## DEVELOPMENT REVIEW BOARD SUPPLEMENTAL SUBMITTAL

PROJECT NO. PR-2018-1580 (1005234)  
Application No. SI-2018-00153

**SUBMITTAL DESCRIPTION:** DRB resubmittal - Use Change from Hotel to Apartment

**EXHIBIT 'A' – Response to comments**

**SITE PLAN PROPOSED USES**

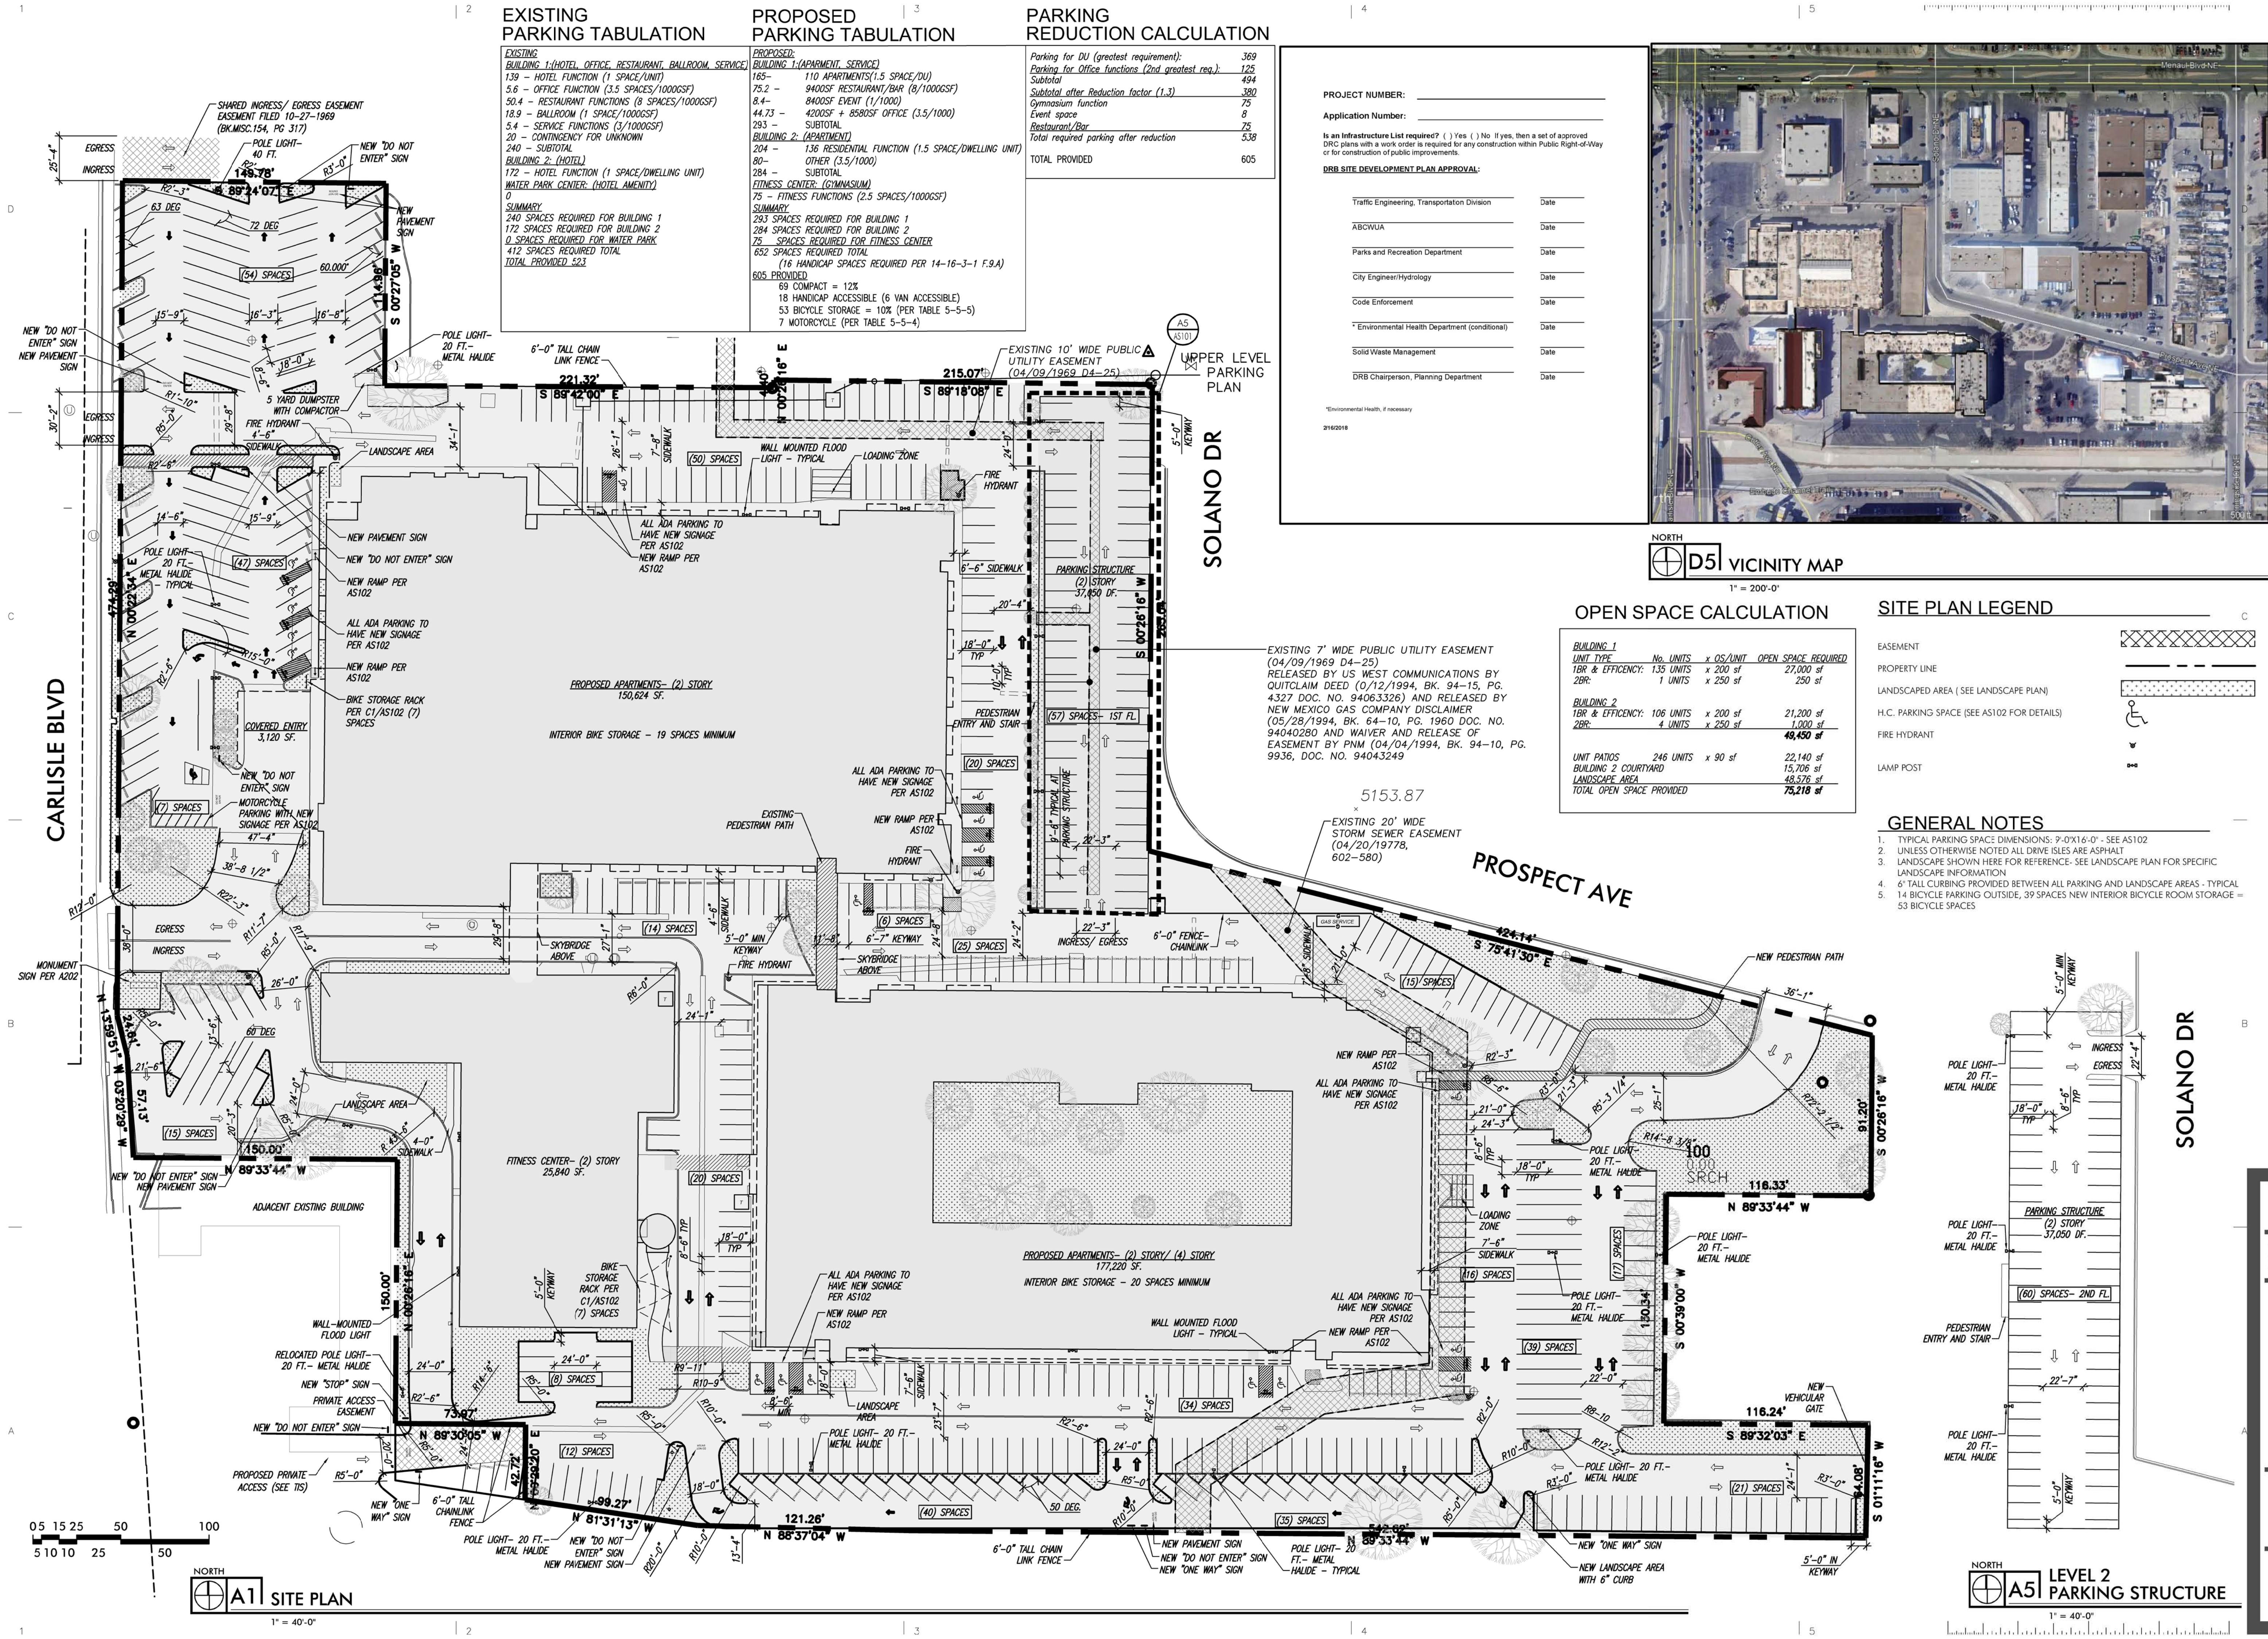
1. *Parking calculation is missing for ADA, and motor cycle parking.*
  - a. **ADA and motorcycle parking calculations have been added to the drawings. Please note the revised Parking Tabulations on AS101.**

1. *Based on the updated calculations, the difference between existing required and proposed parking appears to be an approximately 30% increase associated with the change of use, thus triggering IDO Section 5-5 Parking and Loading requirements.*

- a. **Noted. We believe we have addressed parking per Section 5-5.**
2. *Please show the Shared Parking Reduction calculation and any other credits or allowances on the plan, i.e. on-street spaces. 25% of the spaces are allowed to be compact. Specifying the amount of ADA, compact, and regular spaces in addition to on-street followed by the total would be a helpful breakdown. See Transportation comments.*

- a. **Calculations and requested clarifications have been added to the Site Plan.**
3. *Motorcycle spaces are required. Please show calculation to reflect those provided on plan).*

- a. **Calculations added to the Parking Tabulation on the Site Plan.**
4. *Bicycle parking is required in the amount of 53 spaces (10% of required parking per 5-5(E) of the IDO). Please show calculation and locations.*

C5 SIGNAGE DETAILS

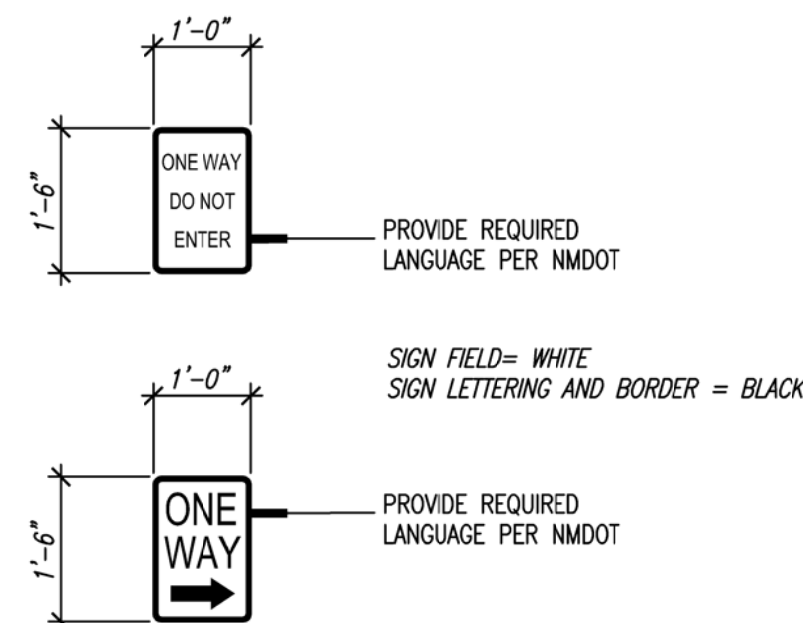
- a. **Keyways have been added and dimensioned.**
4. *One-way vehicular paths require pavement directional signage and a posted “Do Not Enter” sign at the point of egress. Please show detail and location of posted signs. There are missing call outs along the south of the site.*

- a. **Locations have been updated and called out. Sign detail added to AS102.**
5. *Provide details for the rectangular spaces in Prospect Ave. Parking spaces are not laid out correctly.*

B4 MOTORCYCLE PARKING

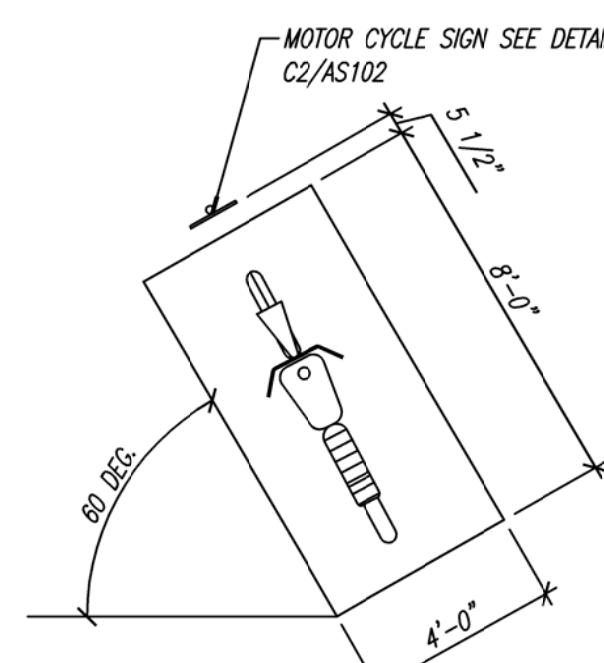
2. *Motorcycle parking detail is mislabeled.*
  - a. **Detail label has been corrected.**
3. *A 5 ft. keyway is required for dead-end parking aisles. Keyway is needed in the parking garage and at the edges of the site.*

Wyndam Suites  
Albuquerque, NM  
Landscape Plan

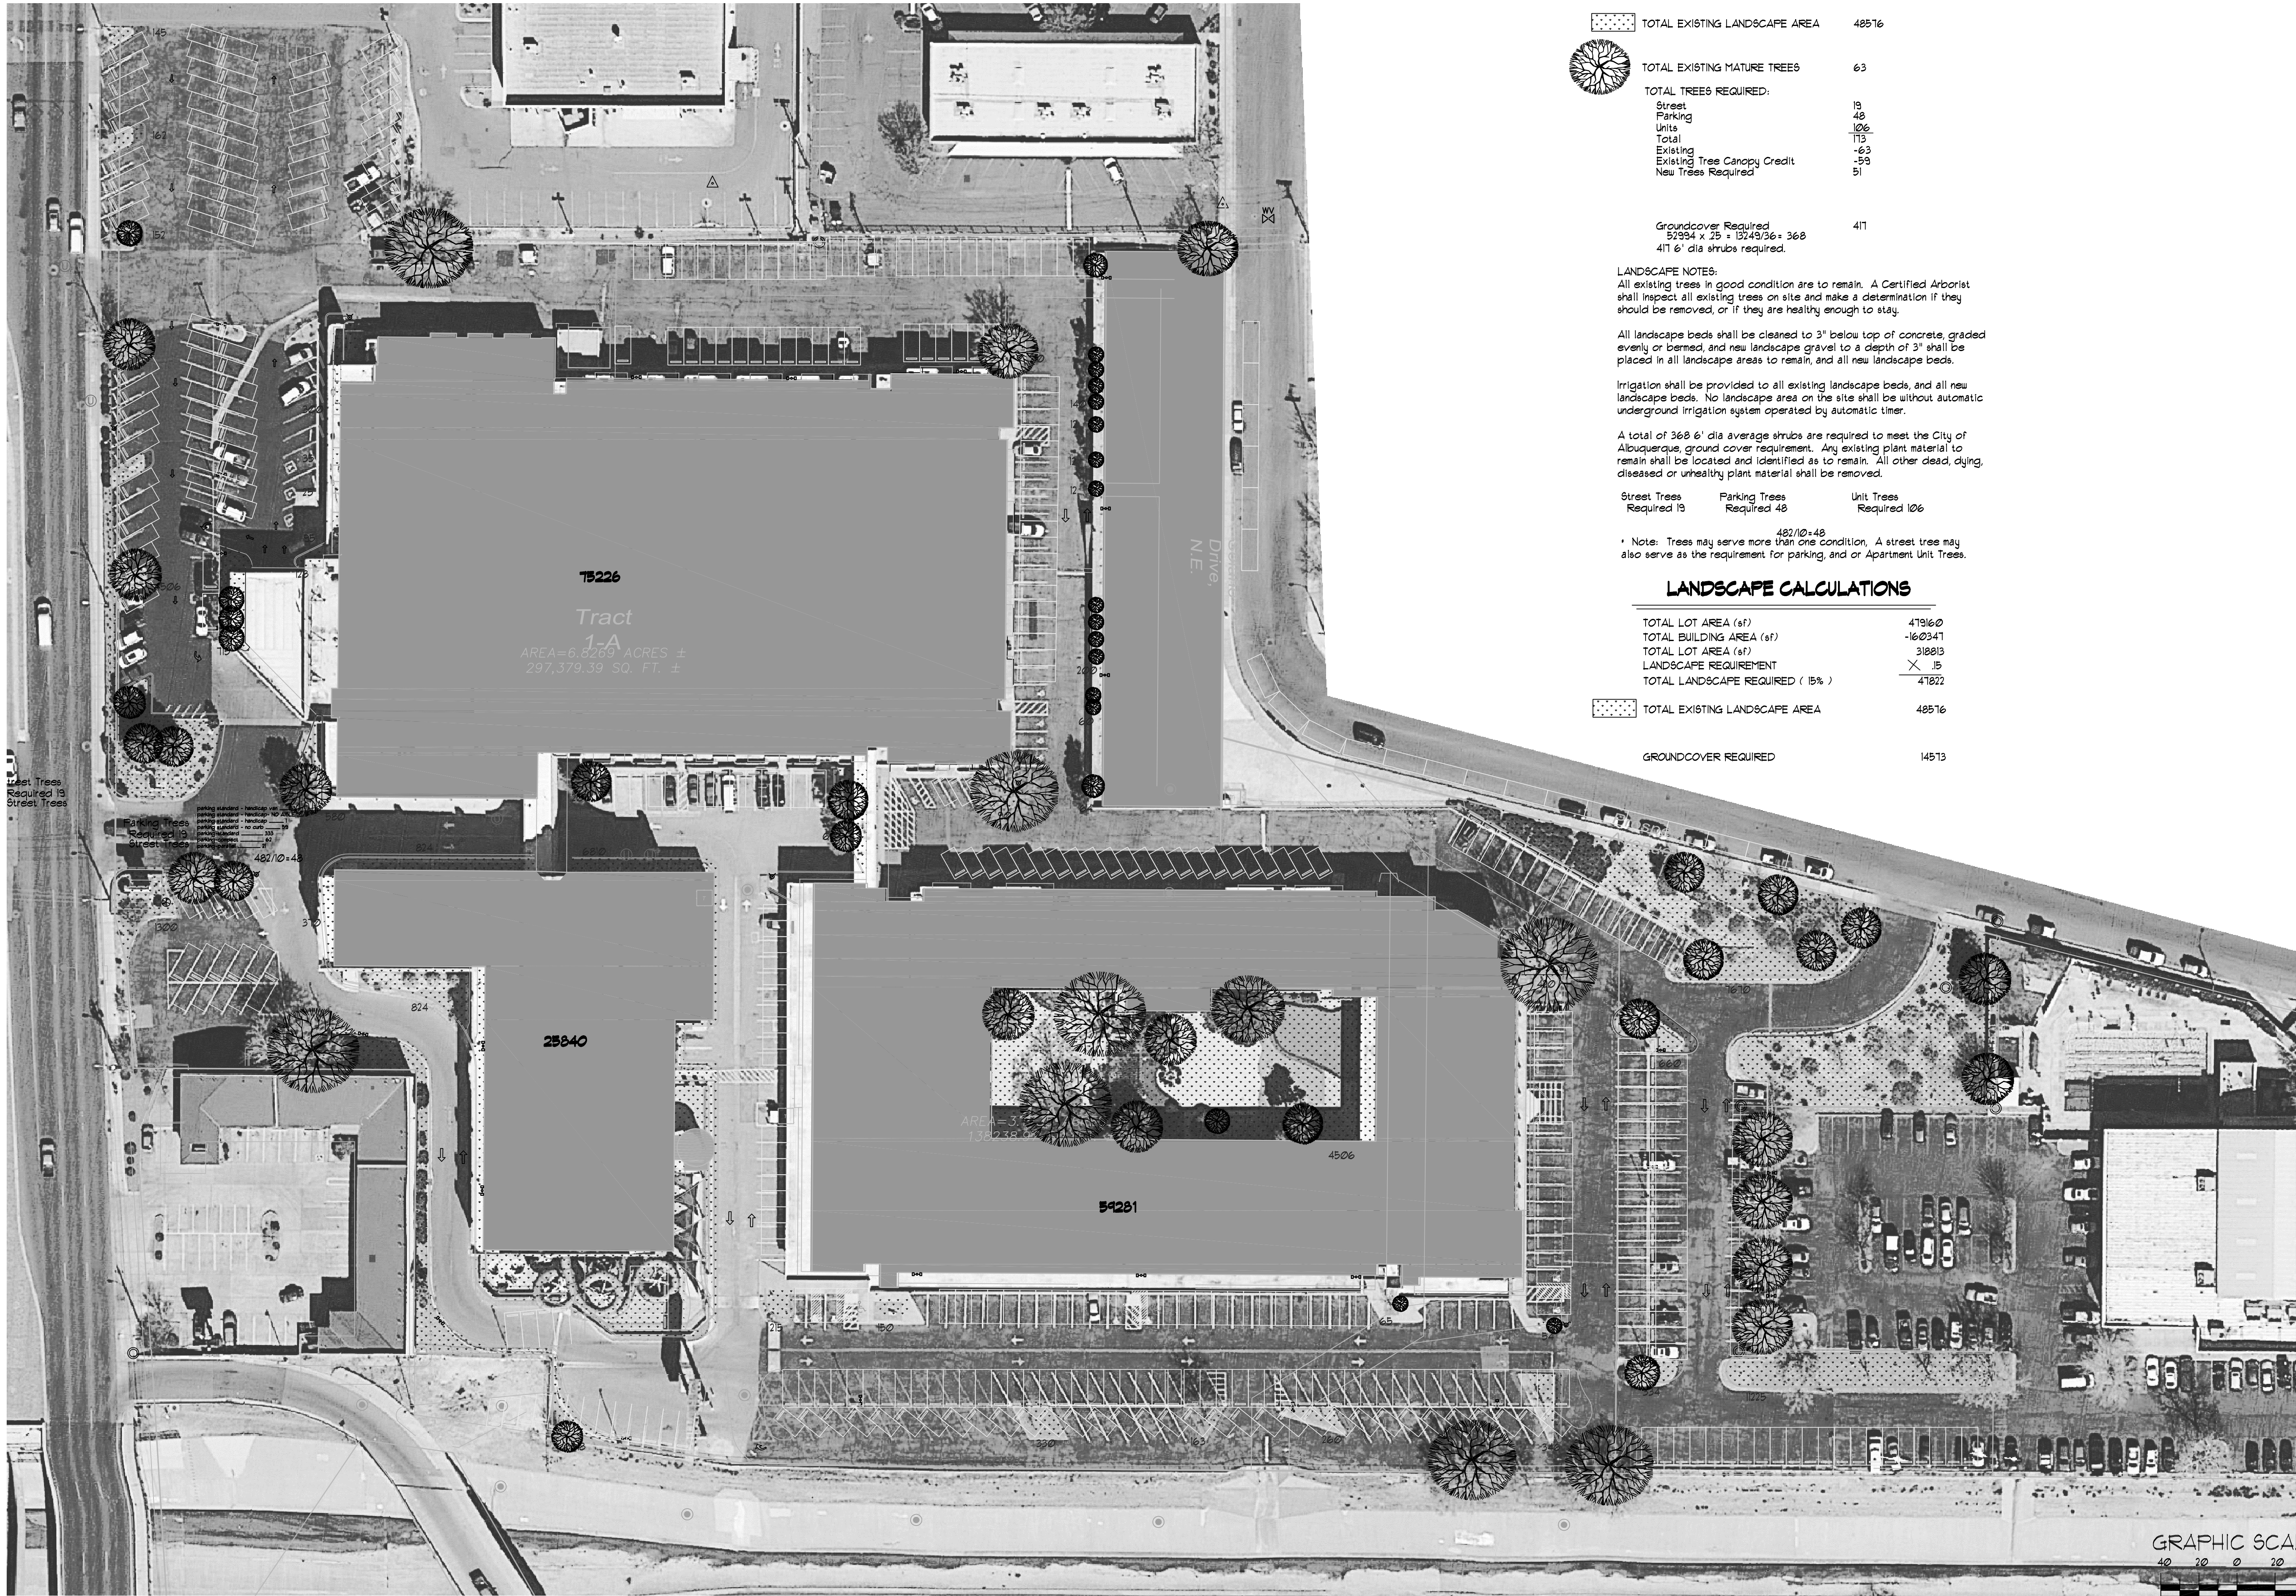
6. *Can the mature spread of plants be calculated on the plan to show how they meet the requirement that 75% of the total landscape area be covered by live materials? 25% of that coverage must be ground level – is this the groundcover number on the landscape plan? A better breakdown from total landscape requirement, 75% coverall amount, the*

7. *Please provide more specific species for the proposed plantings from the official plant list.*

13. *There are two areas on the north sides of Buildings 1 and 2 that have parking spaces farther than 100 feet from a tree.*

14. *Landscape areas should accept stormwater runoff where possible – the curb required by transportation does not have to be unbroken. Small gaps or parking bumpers should suffice for their requirement while also allowing stormwater to pass through into the landscaping.*

**a. Landscape plan updated to include requested calculations.**

**a. Specific species information added to the Landscape Plan.**

**a. These omissions have been corrected on the Landscaping plan.**

**a. A general note to this effect has been added to the Landscape Plan.**
